Lead Local Flood Authority

RE: DM/23/2866 – Land East of Ansty Way, Cuckfield Bypass, Cuckfield, West Sussex

Ansty Garden Community: Flood Risk Assessment and Outline Drainage Strategy,
P25035_R2_Rev1 by Aqua Terra Consulting, August 2025
Letter from Aqua Terra Consulting, 1st September 2025

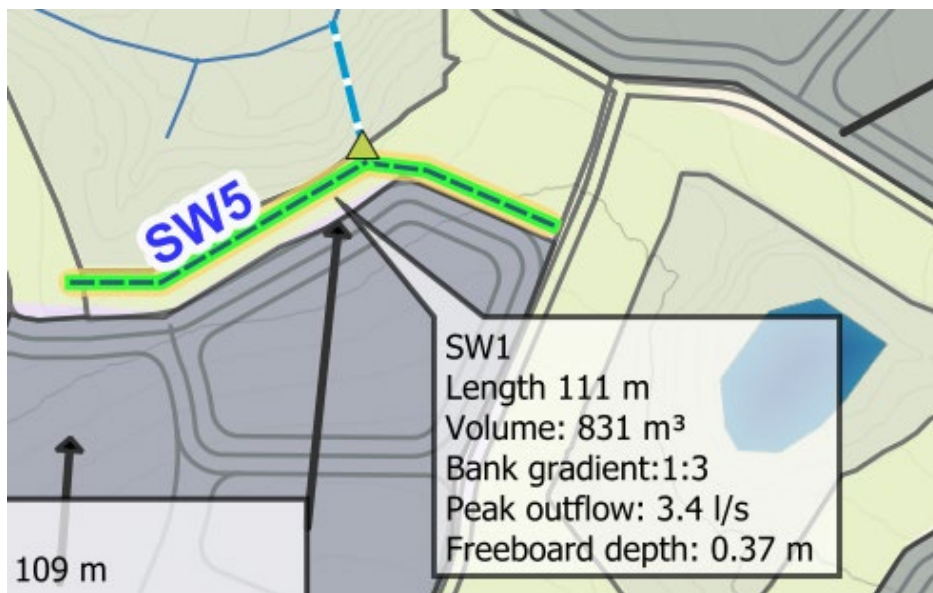
- ~~1. In the greenfield runoff rate calculations, region 1 is being used, which does not reflect the hydrological region for the site. Please send FEH point data file to FRM@westsussex.gov.uk to confirm the location of the calculation inputs. Do not send this to the planning officer, to ensure the data remains confidential and in accordance with FEH Web Service terms of use. Please title the email: *DM/23/2866 FEH point file*. It is essential that the correct parameters are used when calculating greenfield runoff rate, otherwise surface water flood risk could increase elsewhere.~~

This has been adequately addressed.

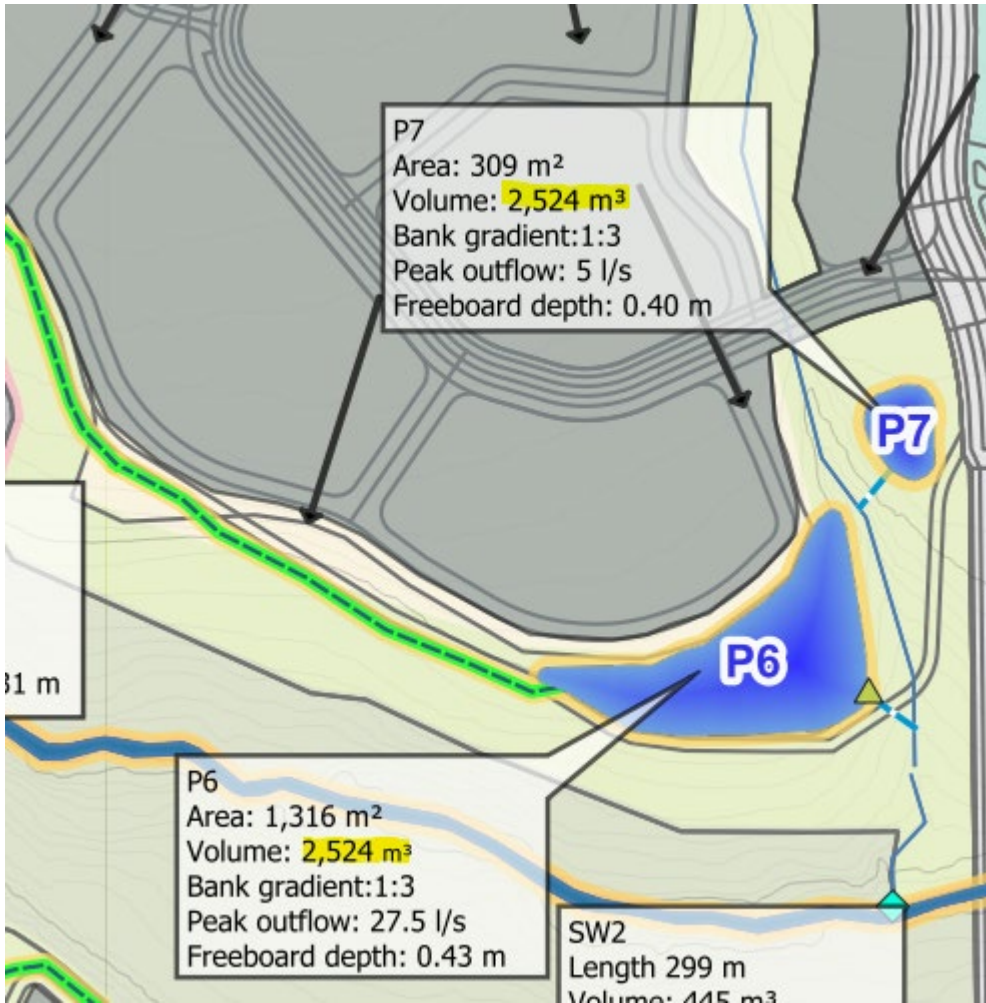
4. At outline planning stage, we require an outline drainage layout showing proposed location of drainage components, storage volumes, outfall locations and a rough idea of flow rates from each outfall. 3m easements will be required around basins and swales. All outfalls to watercourses must be within the red line boundary, or third party agreements will need to be provided at outline stage.

Only the northern section of the outline drainage layout has been updated as requested. It is noted there is some mislabelling (for example see above).

As seen above P6 and P7 are stated to have the same volume, however the calculations do not support this, nor does the area. We request that the outline drainage layout and the calculations are checked and amended to ensure they match and that the modelling reflects the proposals accurately.
